### DESCRIPTIVE REPORT

Type of Survey Hydrographic  
Field No. HSB-10-2-78  
Office No. H-9772

State Pennsylvania and New Jersey  
General Locality Delaware River  
Locality Trenton to Florence

DESCRIPTIVE REPORT  
To Accompany  
HYDROGRAPHIC SURVEY H-9772  
HSB-10-2-78

SCALE: 1:10,000  
DELAWARE RIVER

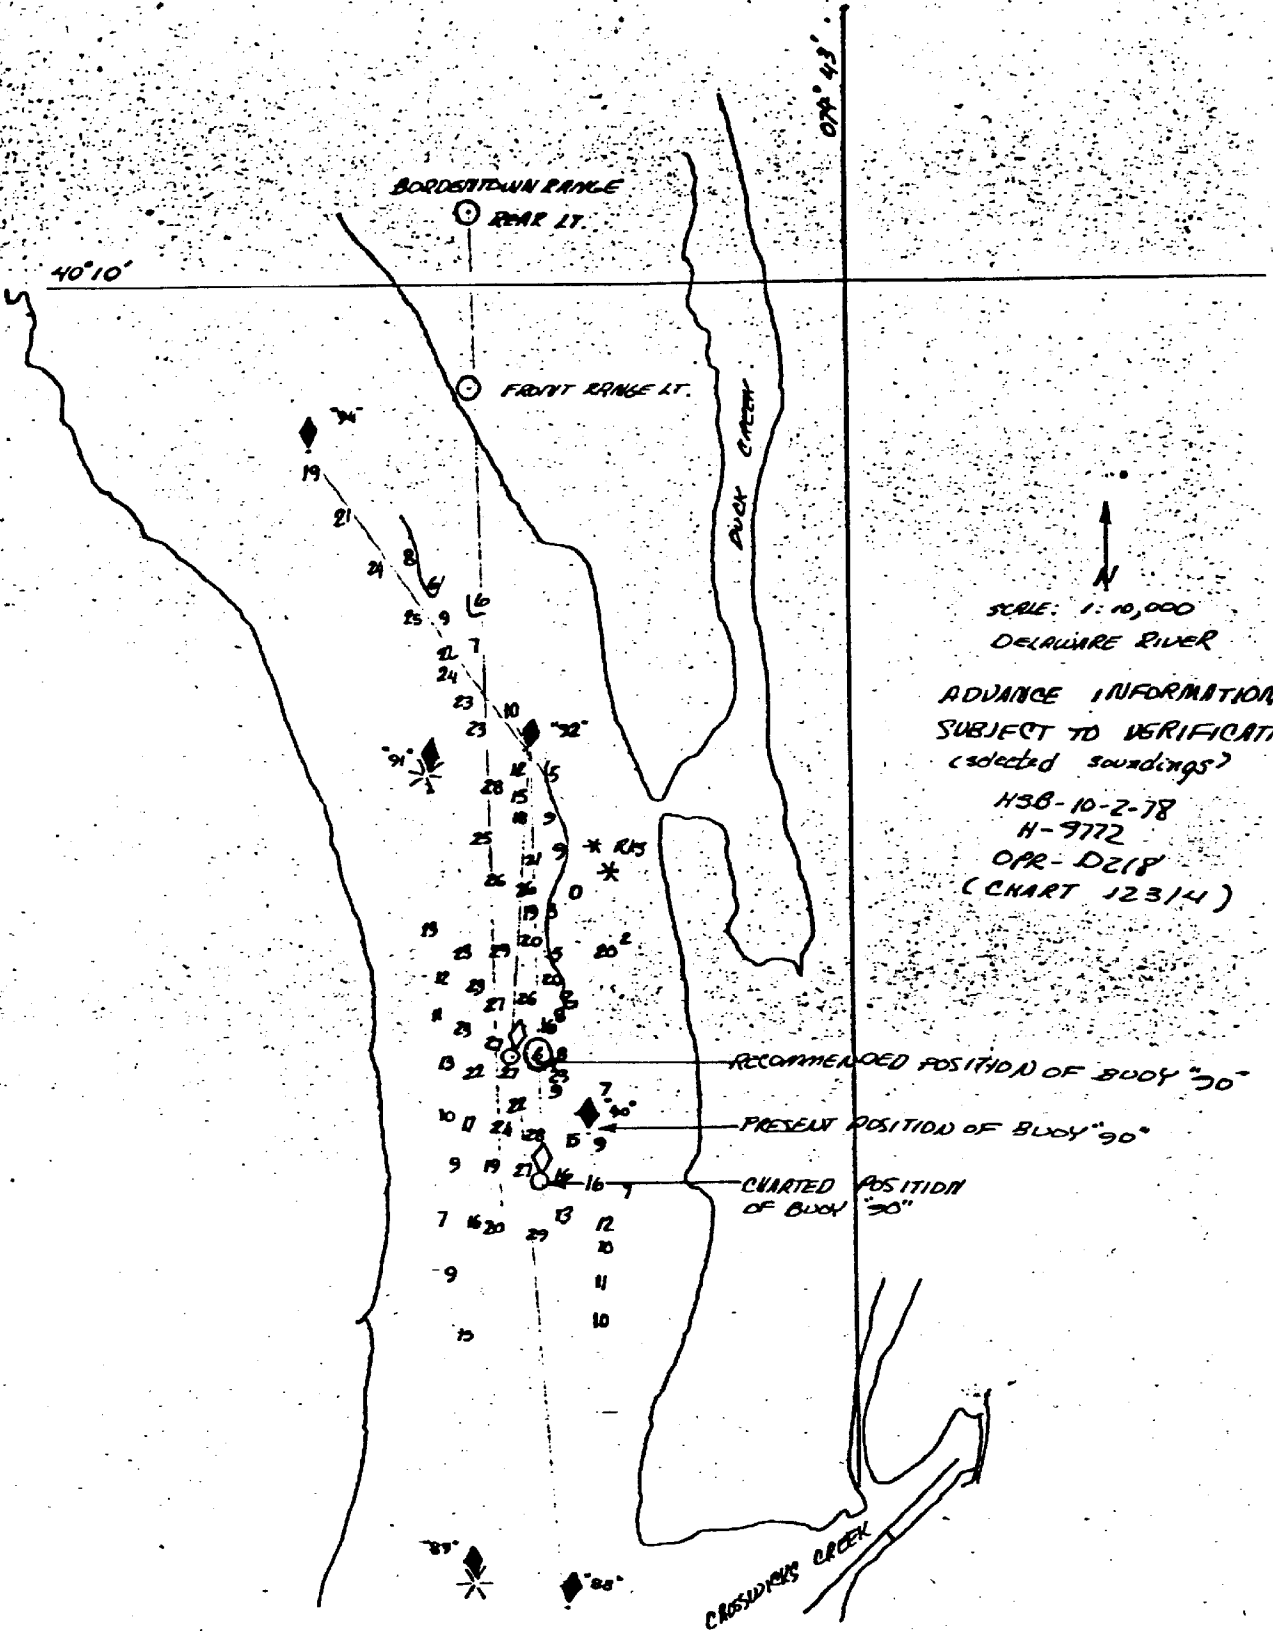
Red num buoy "90" is off station. Instead of returning it to its charted position it should be moved upstream to mark the six foot shoal presently extending into the marked channel.  
(see attached chartlet)

- 1) Re my letter to you dated 5 September 1978, subject recommended relocation of buoy "90"; further investigation has shown the 6 ft. sounding extending into the channel to have been a spurious trace. The buoy, however, remains approximately 100 meters off station and does not accurately mark the channel. Recommend buoy "90" be returned to its charted position.

CHART # 12314

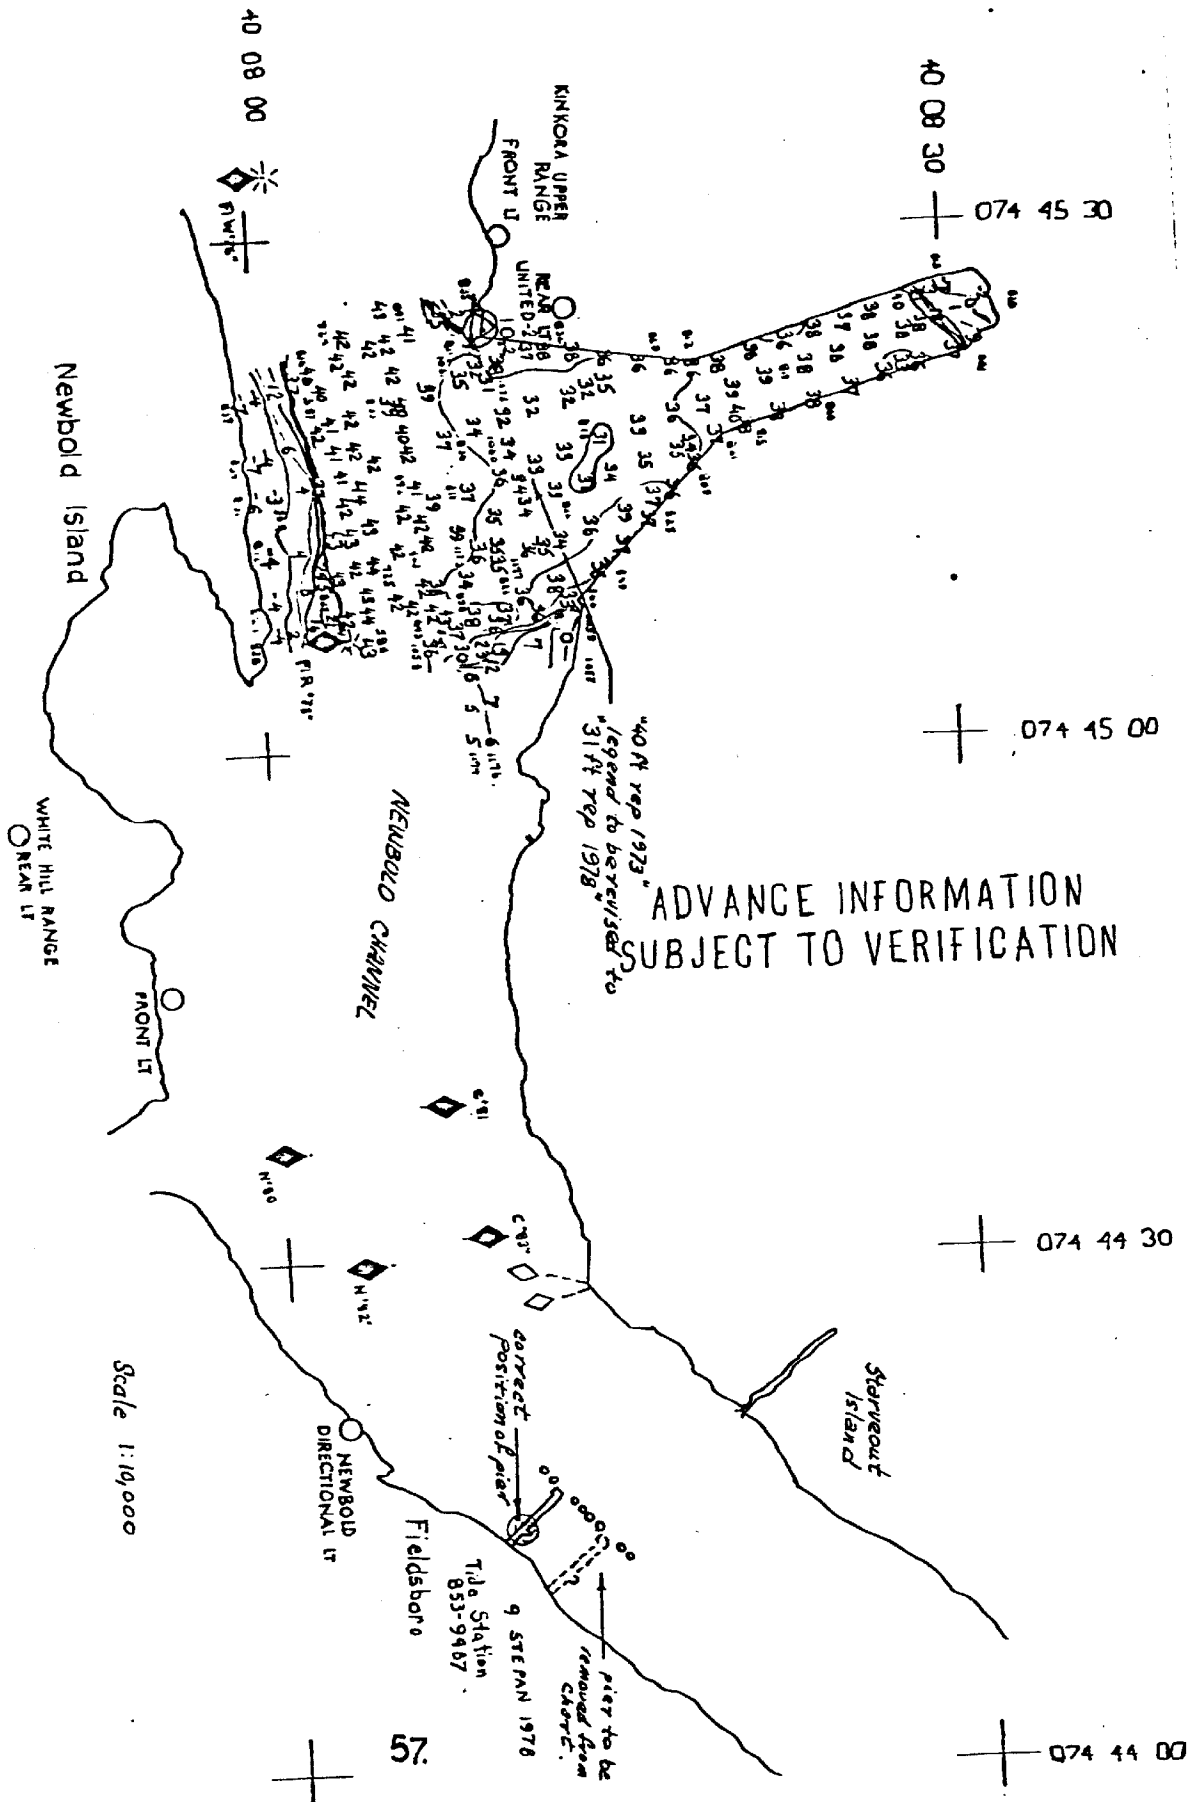
ITEM DESCRIPTION: Shoaling to 31 ft at MLW in an area marked "40 ft rep 1973"

CHARTING RECOMMENDATIONS: Substitute the legend "31 ft rep 1978" for the legend "40 ft rep 1973" until soundings from this survey are applied to the chart.
